CROSSROADS MIXED USE FILING NO. 2

CONSTRUCTION PLANS

V3_Construction Drawings_comments.pdf Markup Summary

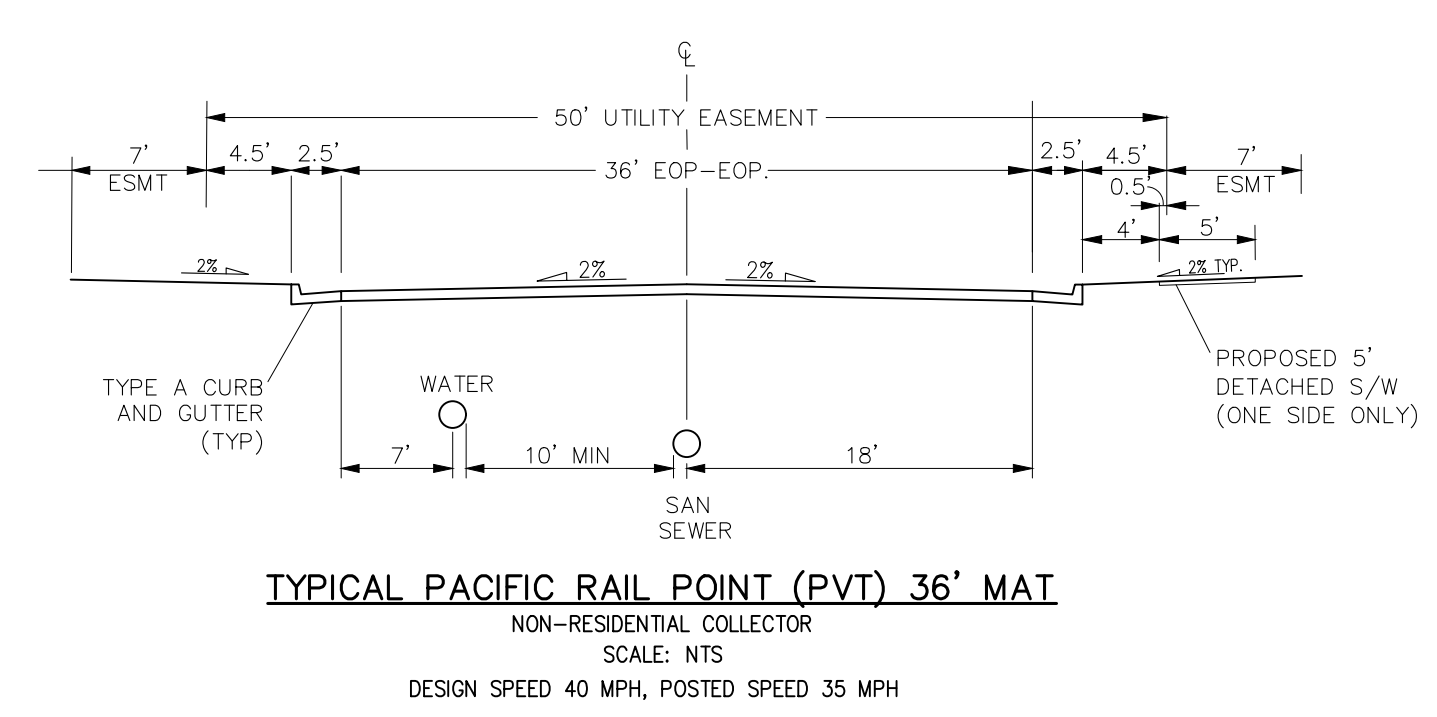
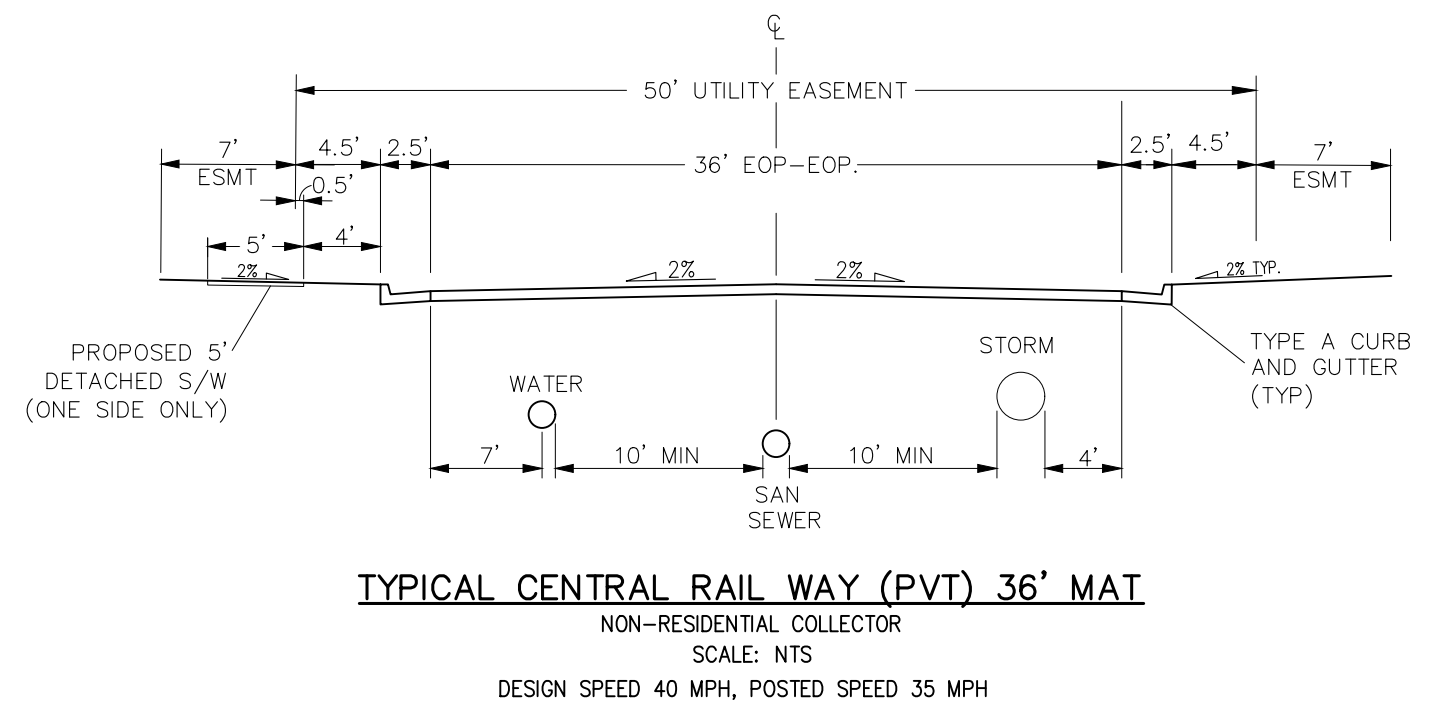
Unresolved from review 1 and 2. Update cross section to provide sidewalk on both sides per the approved deviation request filed under PCD File No SP2011.

Deviation was denied. Please update to include sidewalk on appropriate places.

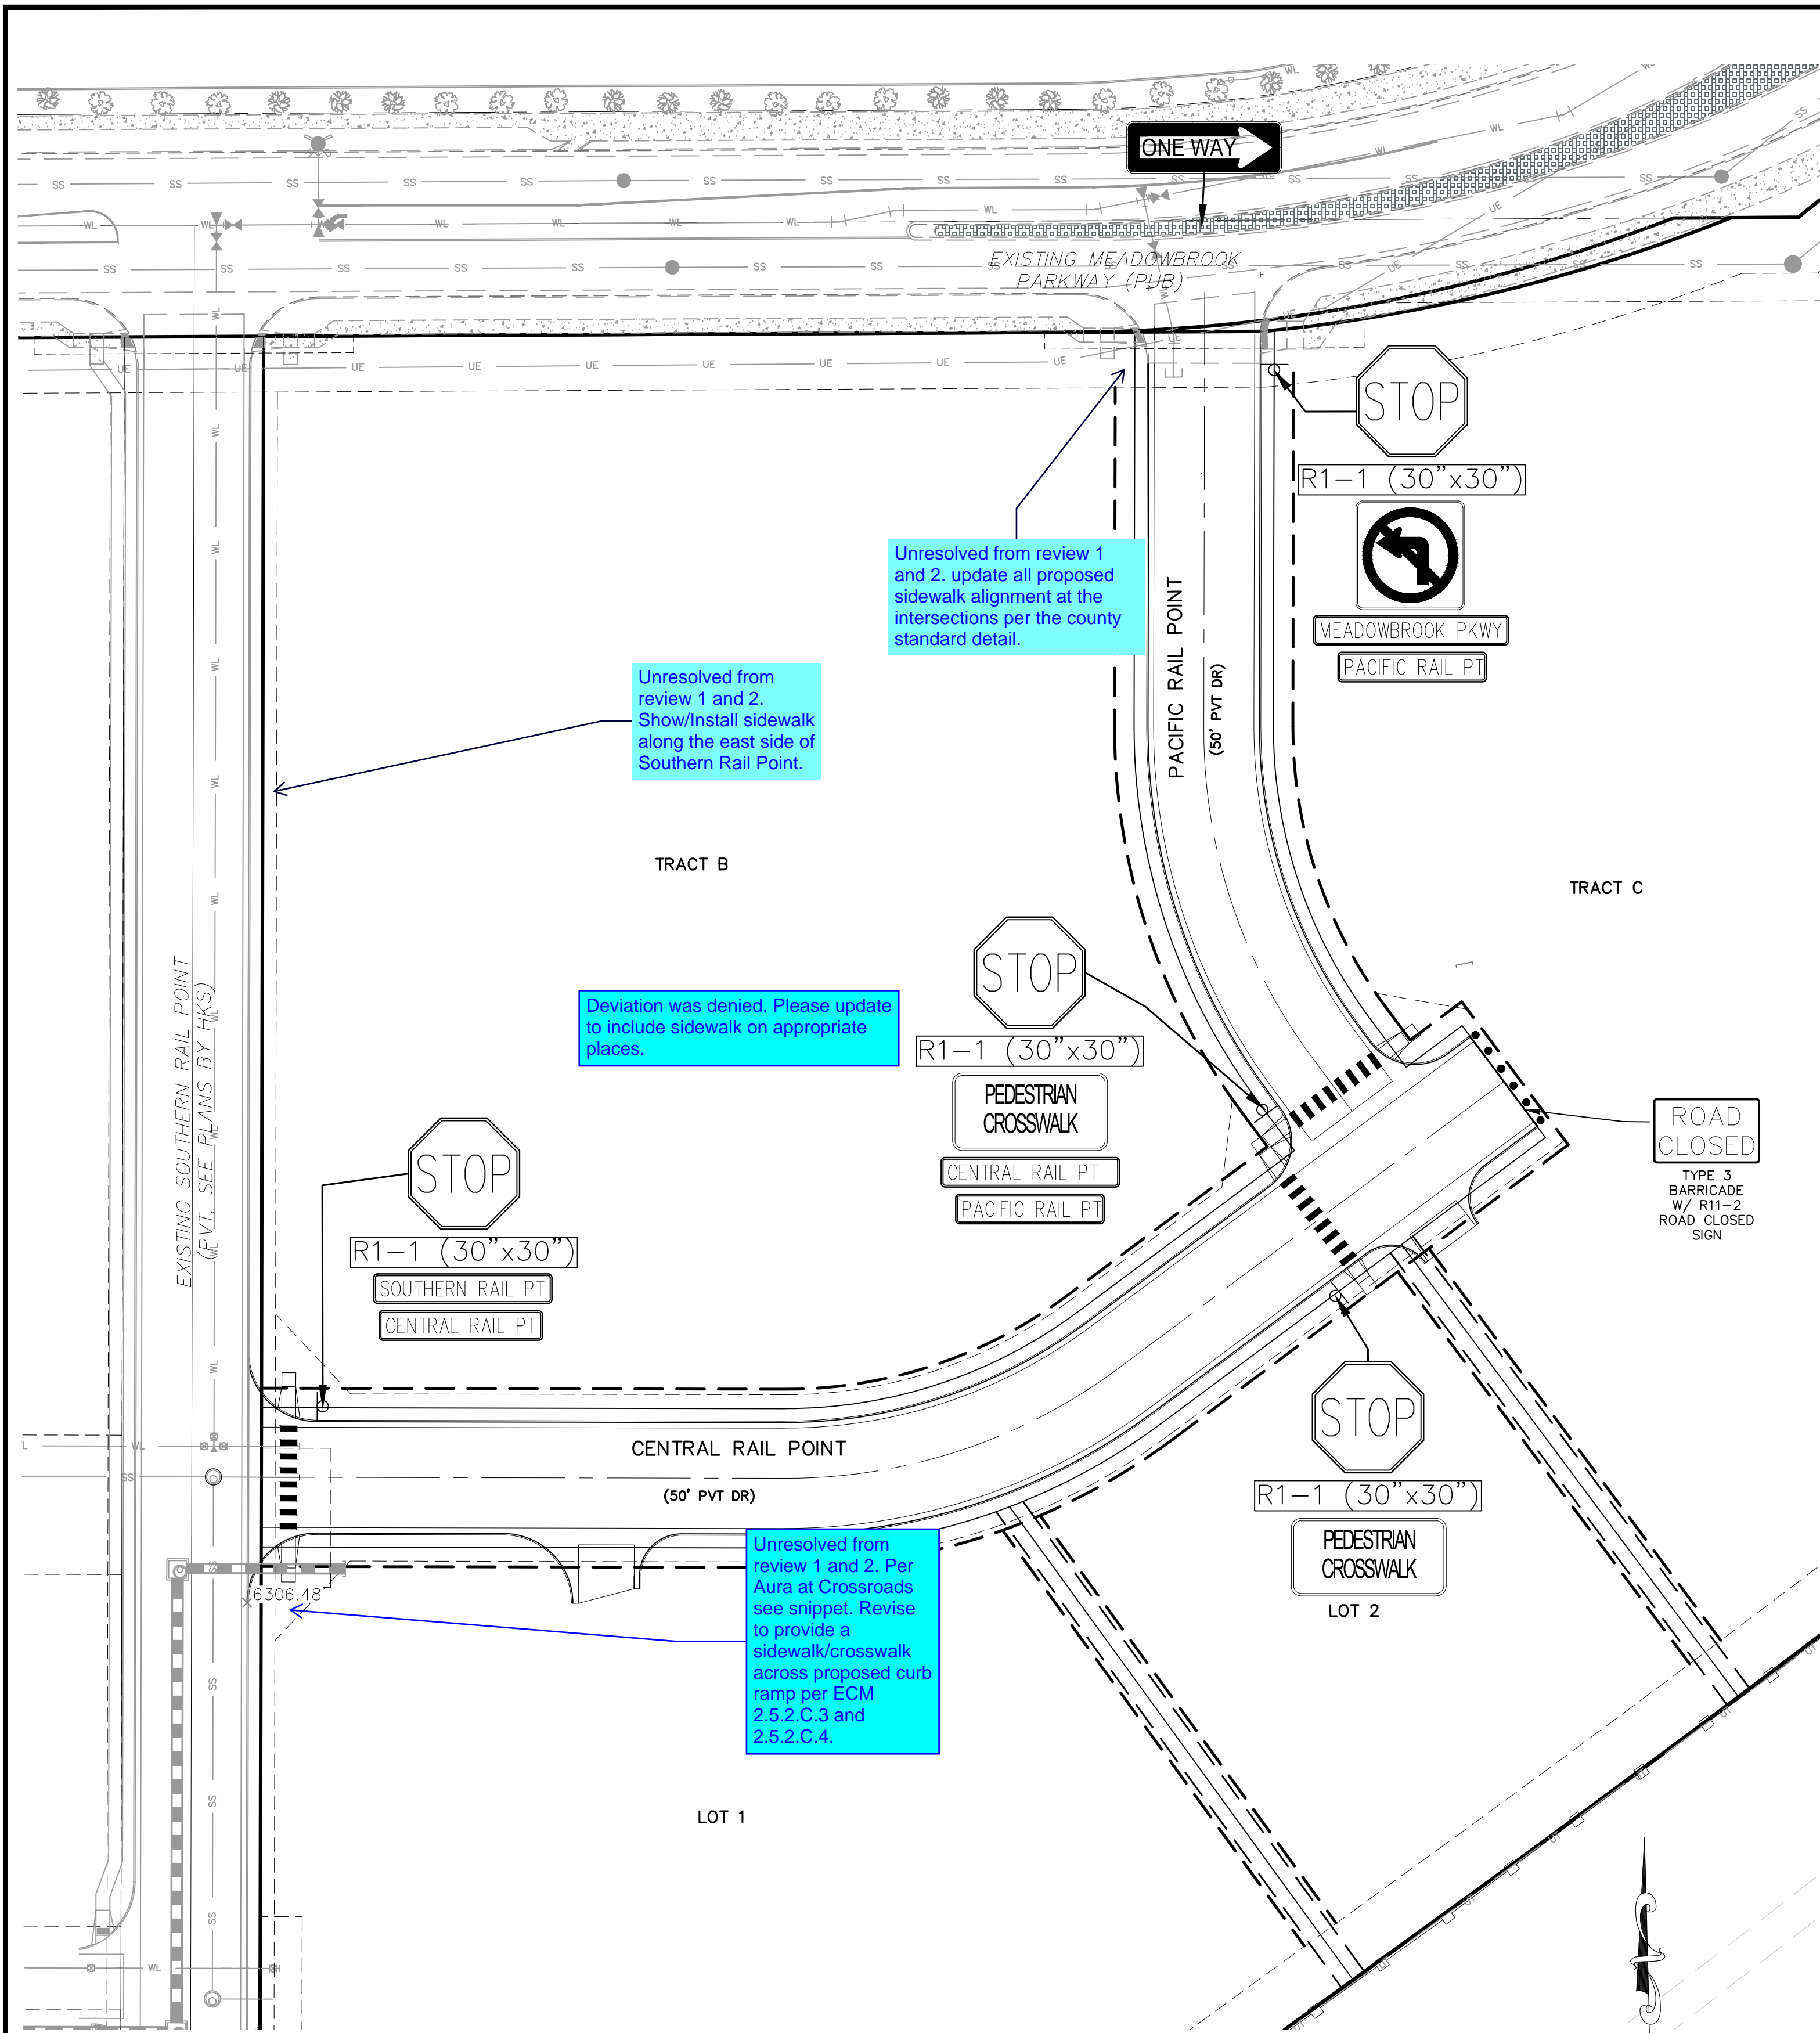
Unresolved from review 1 and 2. update all proposed sidewalk alignment at the intersections per the county standard detail.

Unresolved from review 1 and 2. Show/Install sidewalk along the east side of Southern Rail Point.

Deviation was denied. Please update to include sidewalk on appropriate places.

Unresolved from review 1 and 2. Per Aera at Crossroads see snippet. Revise to provide a sidewalk/crosswalk across proposed curb ramp per ECM 2.5.2.C.3 and 2.5.2.C.4.
